Re: Grants Reclamation Project  
Docket No. 40-8903 License No. SUA-1471  
***Corrections / Edits for "Background Water Quality Evaluation of the Chinle  
Aquifers" – October, 2003 and Associated Statistical Analyses Document***

**REPLACEMENT PAGES  
JUNE 2004**

**GRANTS RECLAMATION PROJECT  
BACKGROUND WATER QUALITY EVALUATION  
OF THE CHINLE AQUIFERS**

**STATISTICAL EVALUATION OF CHINLE AQUIFER  
QUALITY AT THE HOMESTAKE SITE NEAR GRANTS, NM**

**FIGURE C.2-6. MOLYBDENUM CONCENTRATIONS FOR UPPER CHINLE WELLS 931, 934, CW3, CW13, CW18 AND CW40 IN UPPER CHINLE NON-MIXING ZONE.**

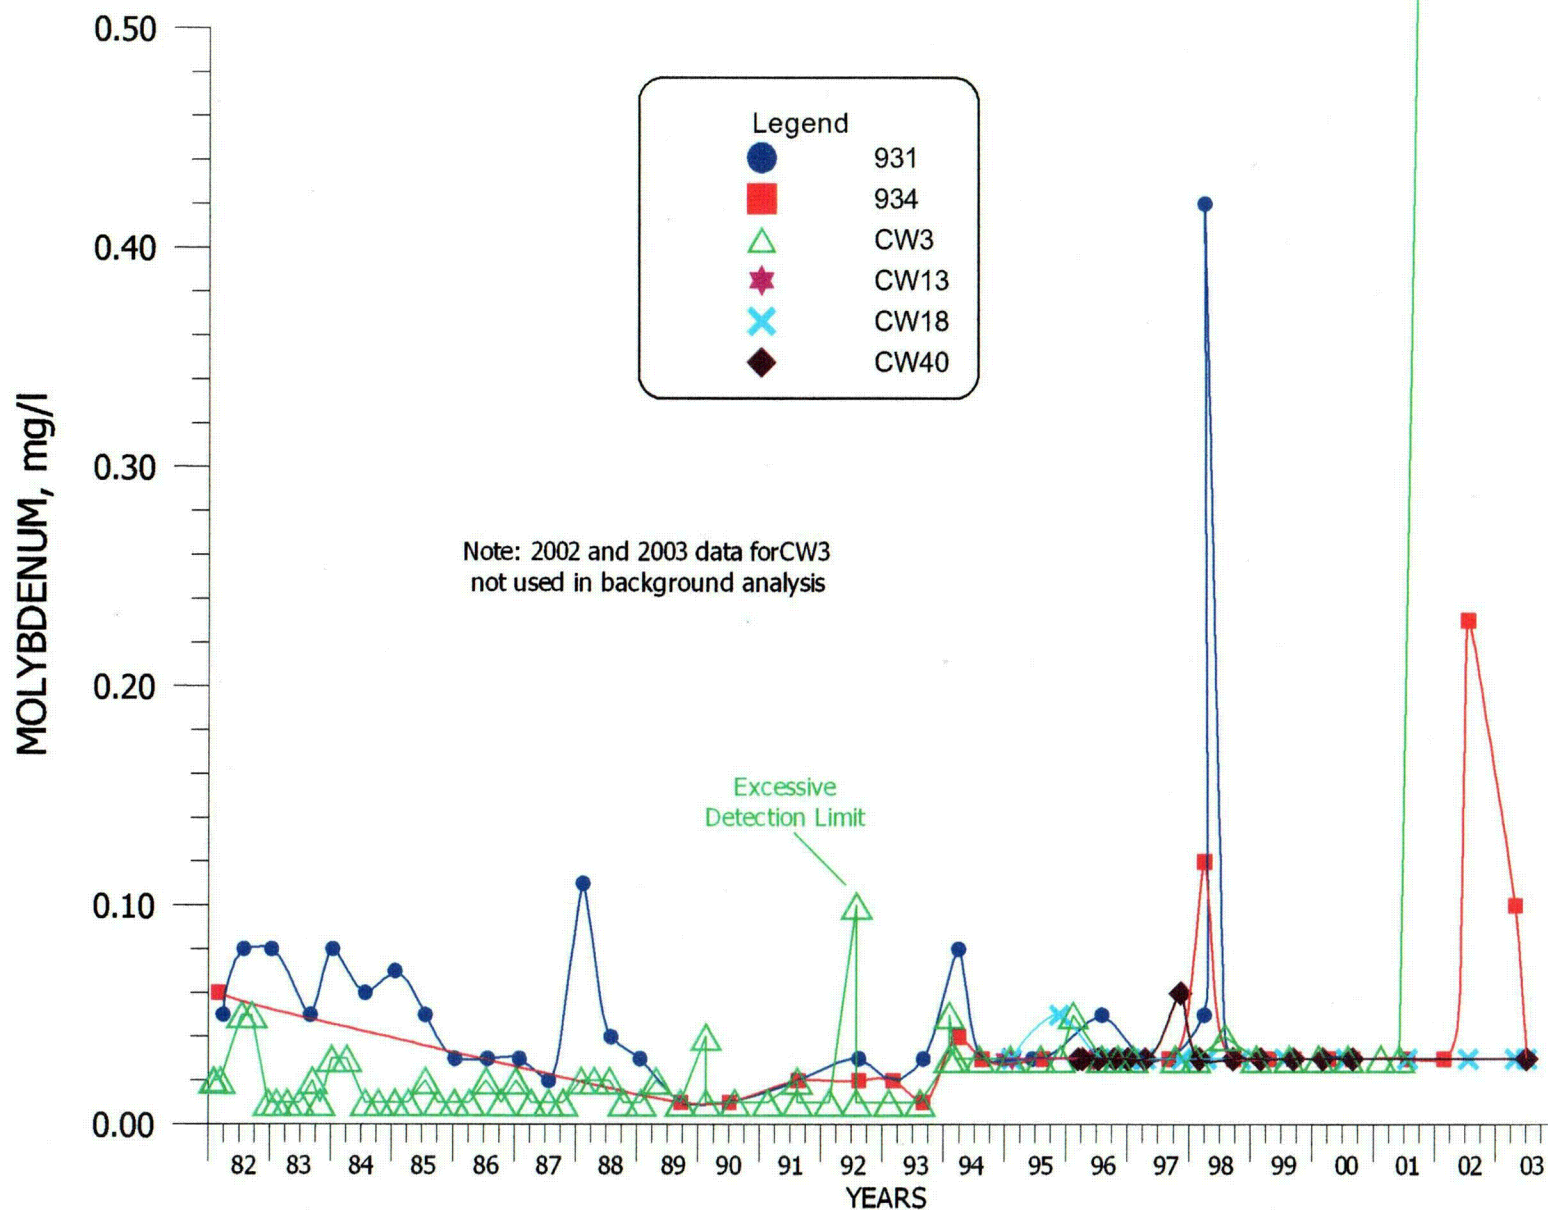
<b><u>Page No.</u></b>	<b><u>Action and Changes</u></b>
Cover	Replace cover page
Page ES-3	Replace pg ES-3 with pg ES-3 modified Table ES-1 vanadium and thorium-230 values
Pgs. 6-1 and 6-2	Replace pgs 6-1 and 6-2 with pgs 6-1 and 6-2 modified Table 6-1 vanadium detection value on pg 6-2, pg 6-1 just reprint
Page 6-11	Replace pg 6-11 with pg 6-11 modified Table 6-4 vanadium and thorium-230 values
Figure C.2-6	Replace Figure C.2-6 (pg C.2-8) with Figure C.2-6 (pg C.2-8) modified with note of excessive detection limit
Figure C.3-6	Replace Figure C.3-6 (pg C.3-8) with Figure C.3-6 (pg C.3-8) modified with note of excessive detection limit
